ADDRESS . . : 89924 *UNASSIGNED
CONTRACTOR : POPE ROBERT
OWNER . . . : JOHNSON LUCAS N & LYNETTE B
PARCEL . . . : 04-0682- - -0216- -13-
APPL NUMBER: 10-50023673 CP NEW RESIDENTIAL (SFD)
DIRECTIONS : T/S: 01/26/2010 09:03 AM VBROWN ----
OFF OF NC 55W CREATURE MEADOW LANE OR
DRIVE. 421S, LEFT ON OLD STAGE RD,
LEFT ON NC 55, 1/4MI CREATURE MEADOW ON
LEFT.

PERMIT: CPSF 00 CP * SFD

JOB JOHNSON RES.
 SHEET NO. 5-1 OF 5-2
 CALCULATED BY [Signature] DATE 5-10-10
 CHECKED BY _____ DATE _____
 SCALE _____

①
 S-2 HIP + VALLEY
 SUPPORT LOCATIONS 1/4" = 1'-0"

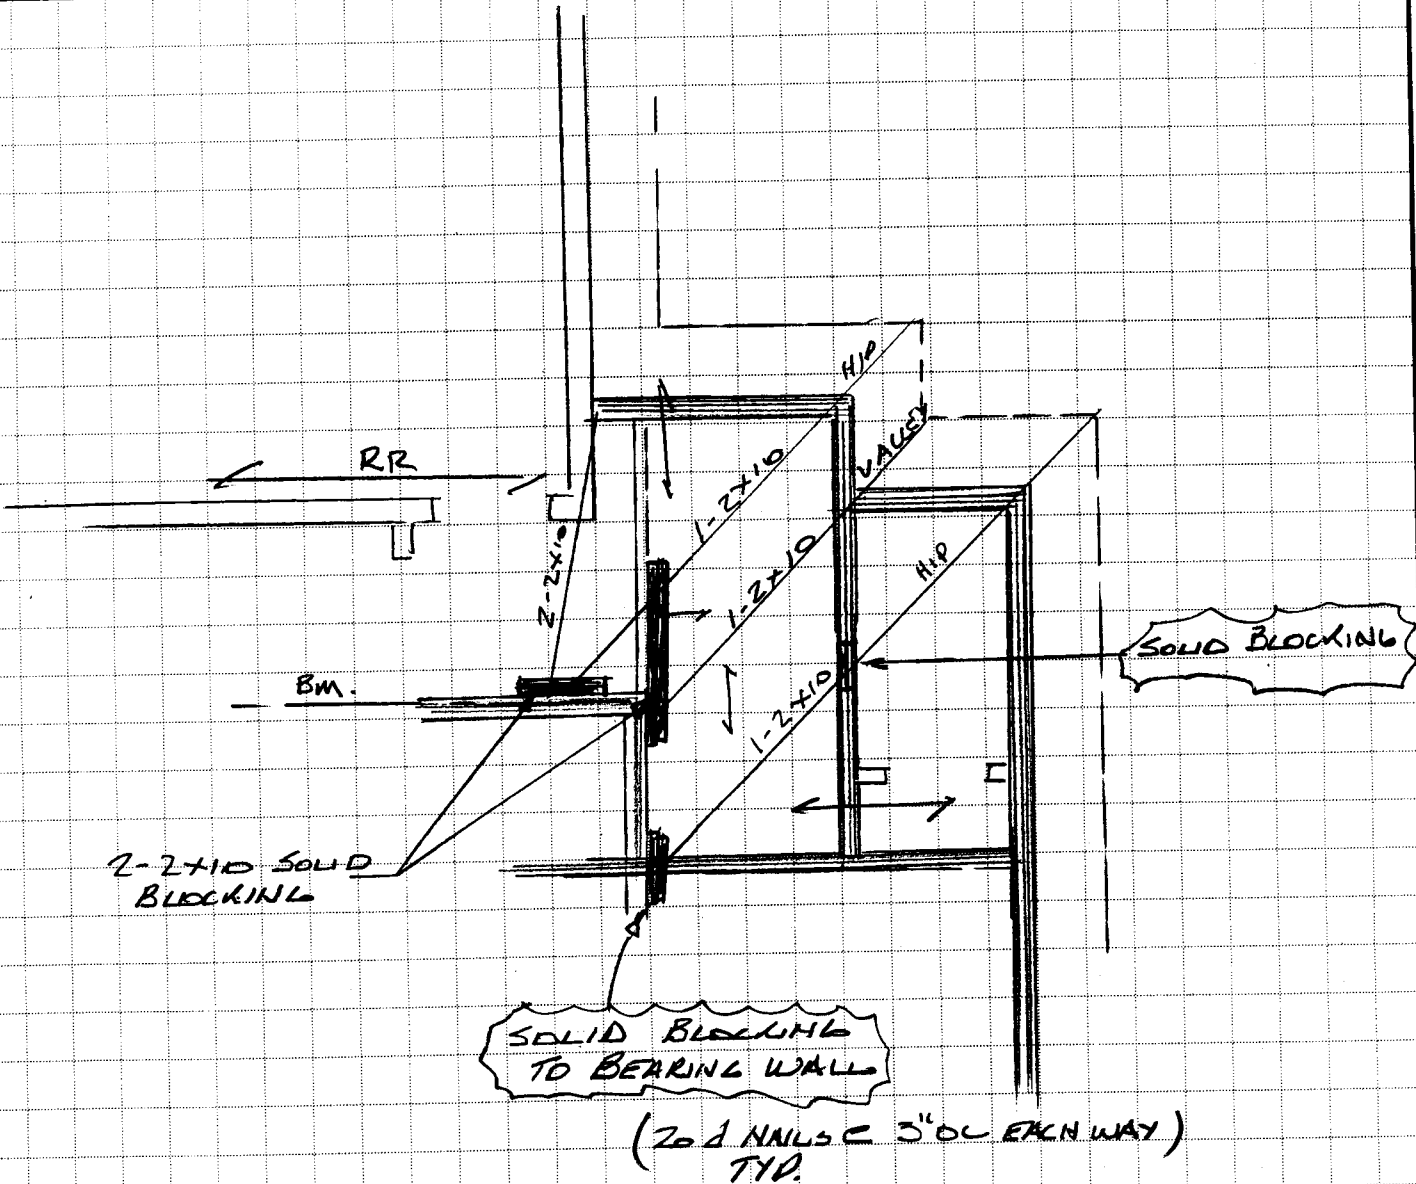
TYP/SQ	REQUESTED COMPLETED	INSP RESULT	DESCRIPTION RESULTS/COMMENTS
B101 01	3/16/10 3/16/10	KS AP	R*BLDG FOOTING / TEMP SVC POLE TIME: 17:00 VRU #: 001895150 T/S: 03/15/2010 01:57 PM RDCONTE ----- ELEC WILL NOT BE AVAILABLE FOR SEVERAL WEEKS. WILL CALL ASAP FOR T-POLE. FOOTING ONLY.
B103 01	3/24/10 3/24/10	KS AP	R*BLDG FOUND & TEMP SVC POLE VRU #: 001899093 VOICE MESSAGE LEFT
B105 01	3/26/10 3/26/10	BS DA	R*OPEN FLOOR VRU #: 001900651 Plan calls for a triple 2x10 girder in span on rear of house. SEE PLAN DO NOT COVER. Call to reschedule
B105 02	3/29/10 3/29/10	BS AP	R*OPEN FLOOR VRU #: 001901384 VOICE MESSAGE LEFT
A814 01	3/30/10 4/01/10	TW AP	T/S: March 29, 2010 11:46 AM BSUTTON ----- ADDRESS CONFIRMATION TIME: 17:00 VRU #: 001899468 251 creature meadow ln # on house and by drive angier 27501
R425 01	5/04/10 5/04/10	BS DA	T/S: 04/01/2010 09:37 AM TWARD ----- FOUR TRADE ROUGH IN VRU #: 001920023 VOICE MESSAGE LEFT 1. Hurricane ties on kitchen rafter. 2. Strap vent At master bath. 3. Nail plate in foyer for electrical. 4. Through bolt deck bands to house. 5. Reframe ceiling over stair opening to support roof hip/valley. 6. Need engineering on change from 2- 11 7/8 to 3 9/14 LVL over kitchen 7. Need engineering on double 2x10 right rear side of house supporting wall/roof loads, and hip/valleys supported on non-load wall below. Ok to side. Do not insulate
